**9801 GEORGIA AVENUE
SKETCH PLAN NO. 320230020**

No. 320230020

Item No. 9
3-30-2023

Figure 4 - Georgia Avenue Facades

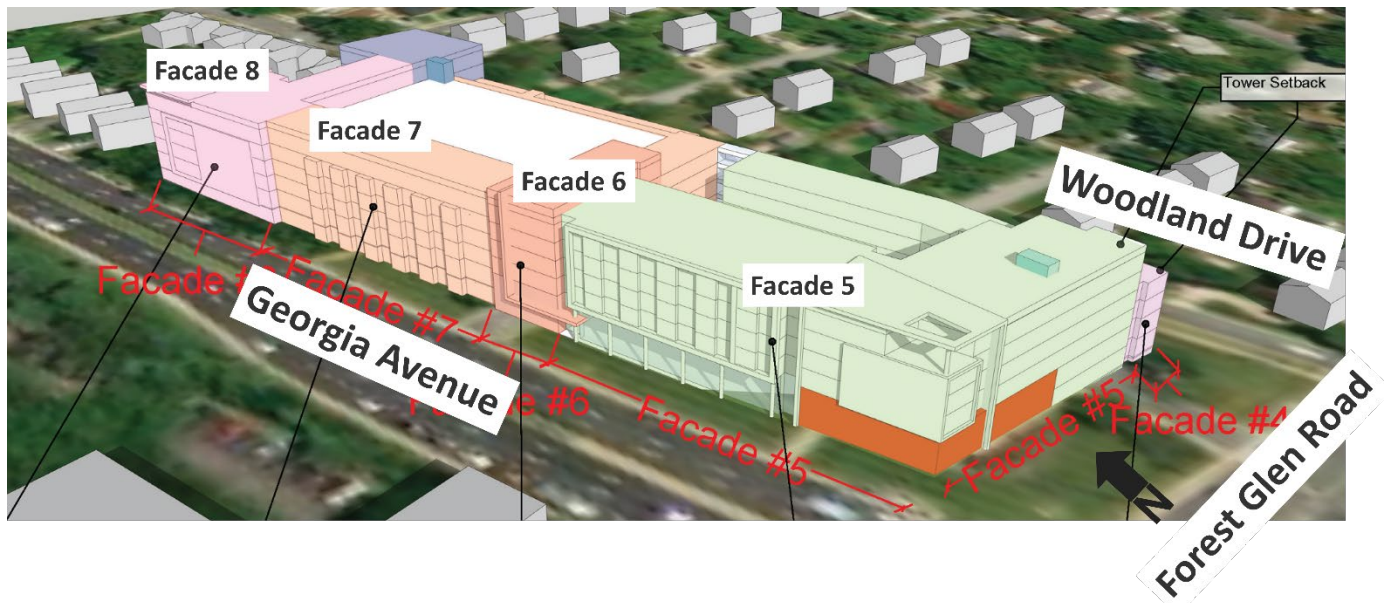
- i. Utilize setbacks, varied materials, and articulation to differentiate façades 5, 6, 7 and 8 on sheet number 20-ARCH-320230020-003.
 - ii. Set back the building's mass a minimum of 10 feet above the fourth floor along façade 8 (on sheet number 20-ARCH-320230020-003).

Figure 7 - Southern Open Space

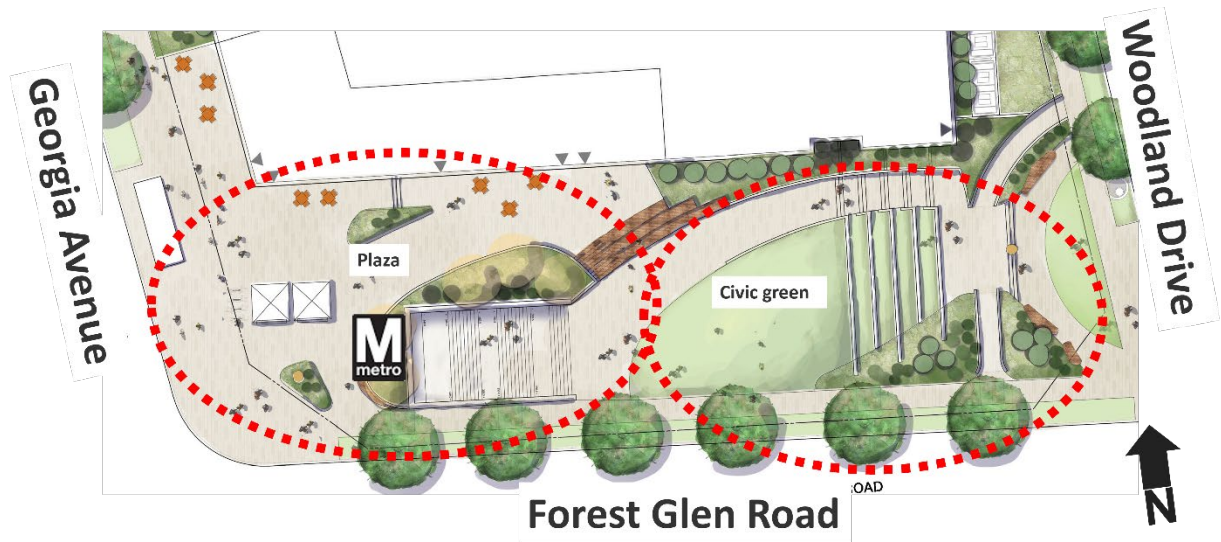
The Sector Plan recommends a civic green urban park ranging in size between ½ and one-acre at the Site. A civic gathering space is defined by the Sector Plan as a contiguous space of ½ acre or more that can accommodate cultural programs, community events and neighborhood festivals. The Applicant proposes a plaza and open space of approximately 0.38 acres along the southern portion of the Site. The proposed plaza includes a series of stepped terraces, with a combination of hardscape, lawns, landscaped plant beds, and outdoor seating. The combination of terraces provides opportunities for gathering spaces and performances, as well as informal outdoor seating to serve patrons of the adjacent retail as well as the Forest Glen Metrorail Station. The civic green should be enlarged to a minimum size of ½ acre of usable space.

Figure 9 - Recommended Woodland Drive Building Massing

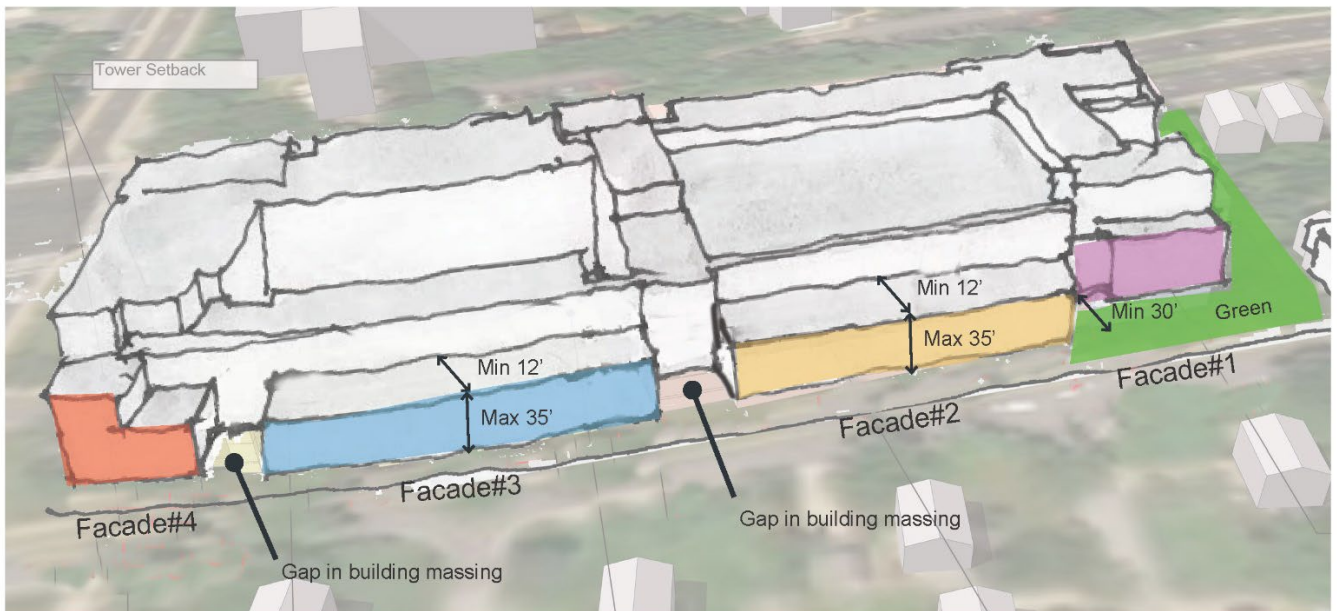
- a) Woodland Drive. At a minimum, the proposed Woodland Drive building façade must be revised to ensure compatibility with the residential neighborhood. Design elements should consider the following (as shown in Figure 9 on page 22):

- ii. Set back Facade 1 by a minimum of 30 feet to create an open space at the northeastern corner of the building.
 - iii. Provide residential-scale porches/stoops for units at the ground level to facilitate direct access from the abutting Woodland Drive sidewalk.

- v. Set back the building's mass above 35 feet of height by a minimum of 12 feet from the primary façade along Woodland Drive.
 - b) Georgia Avenue. At a minimum, the proposed Georgia Avenue building façade must be revised at the time of Site Plan to break down the building mass. Design elements should consider the following:

The proposed building is nearly 600 feet long on the Georgia Avenue and Woodland Drive sides, and the development encompasses 2 ½ blocks of land. While the Applicant has proposed some articulation, building design conditions of approval will require a meaningful transition and step-down to the single-family neighborhood to the east. The intended result of these conditions is shown illustratively, in the Staff drawing below, to demonstrate the effect of building massing on Woodland Drive.

Staff recommends that the building façade along Woodland Drive include more substantial building step-backs and articulation to respond to the lower-scale residential neighborhood across Woodland Drive. These design changes will help the building respond to the surrounding context and provide a more compatible building transition.
